## **CITY OF MEMPHIS**

## **PRIMARY CLARIFIER SLUDGE PUMP STATION REHABILITATION FOR THE TE MAXSON WASTEWATER TREATMENT FACILITY**

### **Addendum Two (2)**

**City Project: SW02033**

**BASEMENT LEVEL - DEMOLITION PLAN**

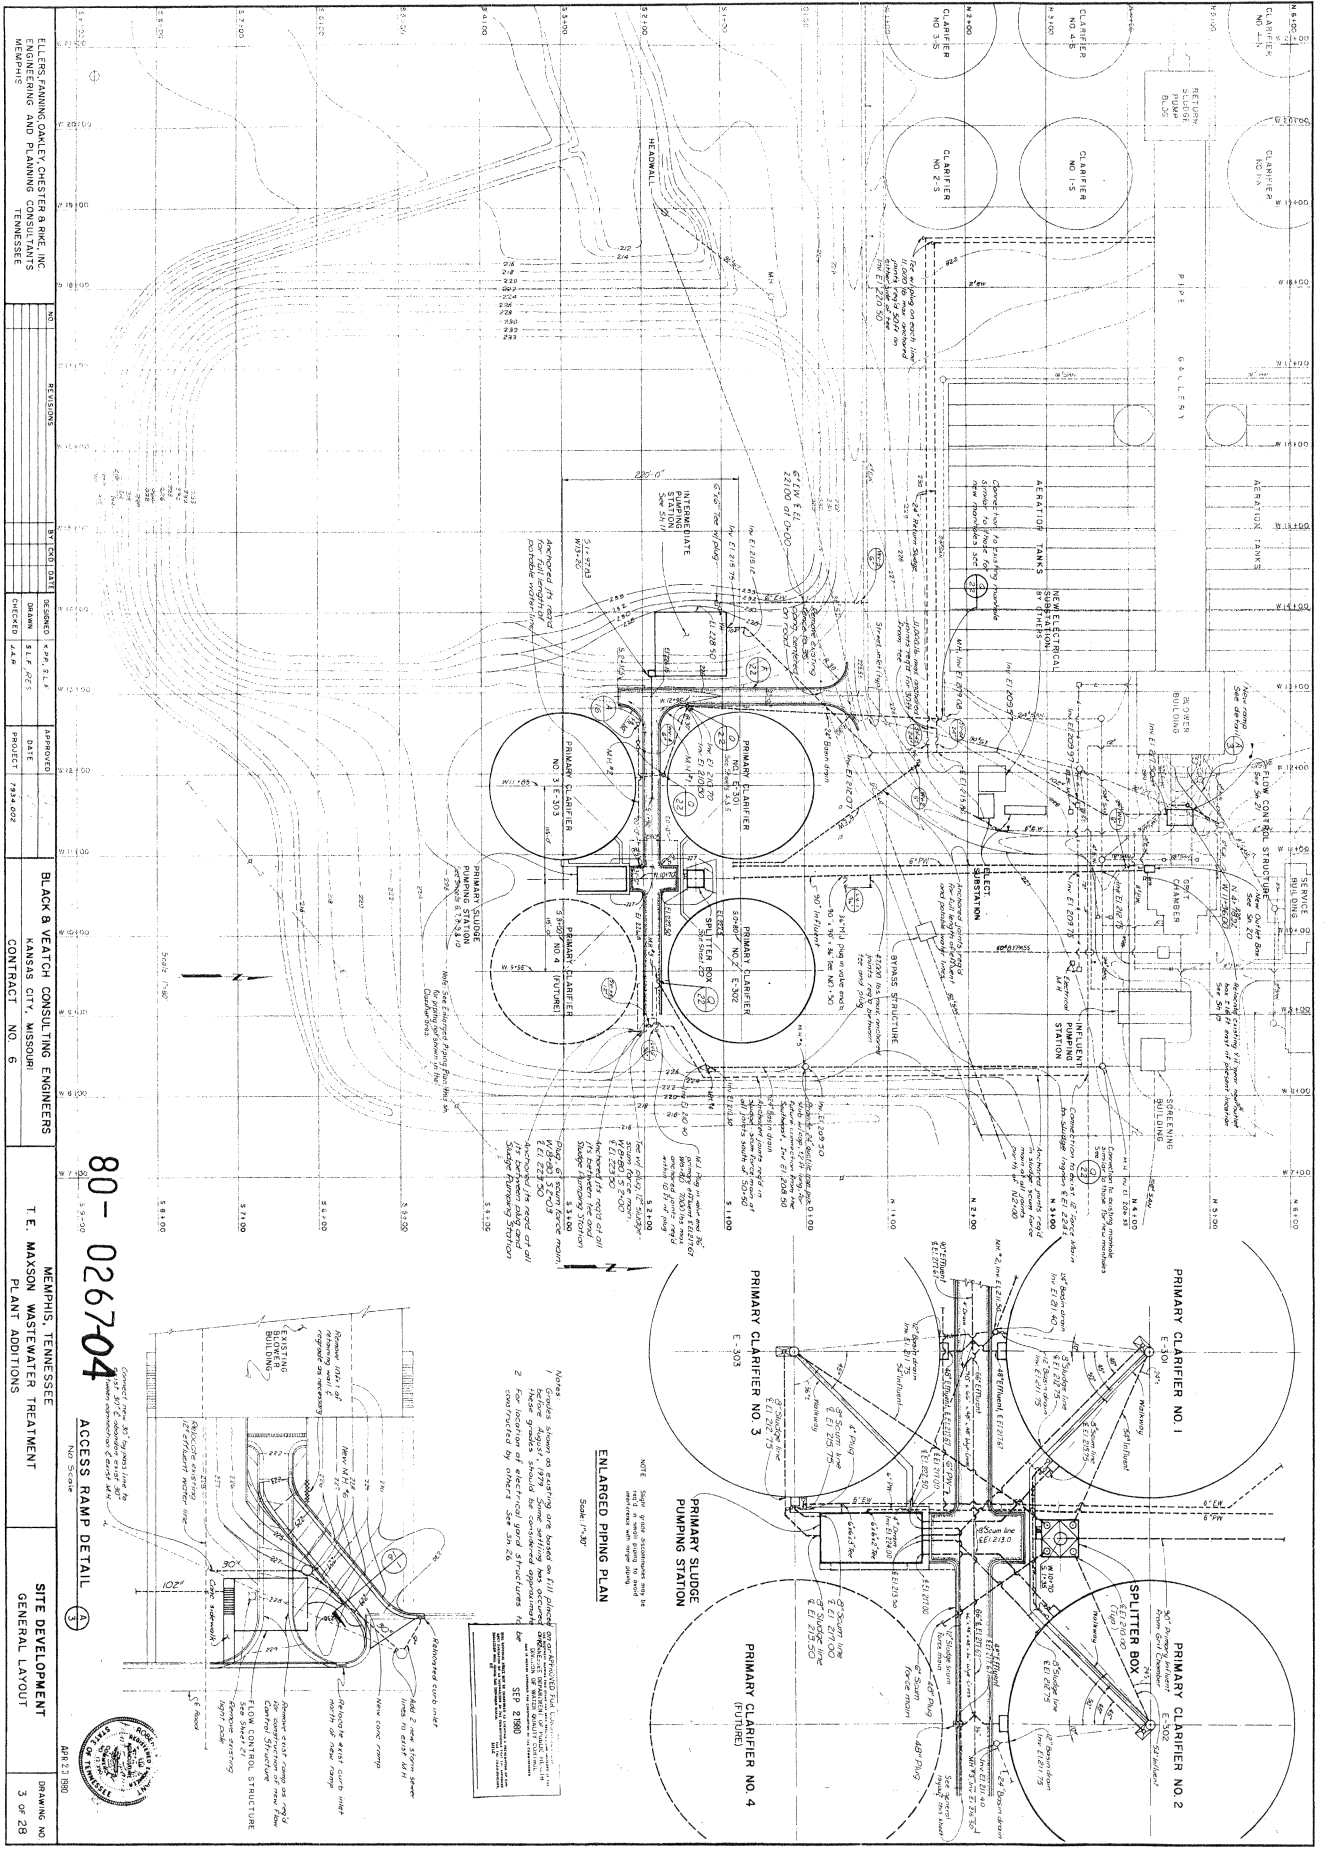
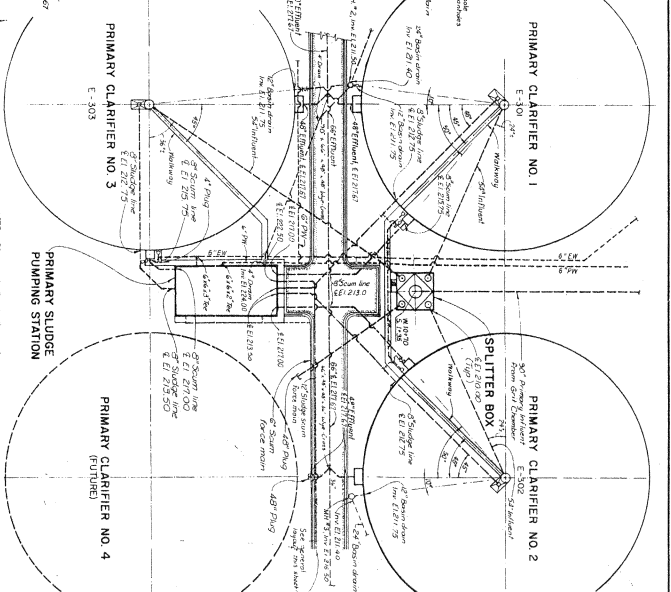
Q3: The limits of demolition are not clearly defined on the plans. Can you provide a demolition plan?

Q5: Is there an "existing conditions" drawing for the pump and pipe room?

BV: Pump room demolition is included with a new sheet, D2.0. It also includes existing conditions. Electrical demolition phasing will be determined by the Contractor based on use of the existing MCC for powering temporary bypass pumps. It is expected that the existing MCC and associated equipment will be demolished once the new electrical building and MCC are in use.

BV: Pump room demolition is included with a new sheet, D2.0. It also includes existing conditions.
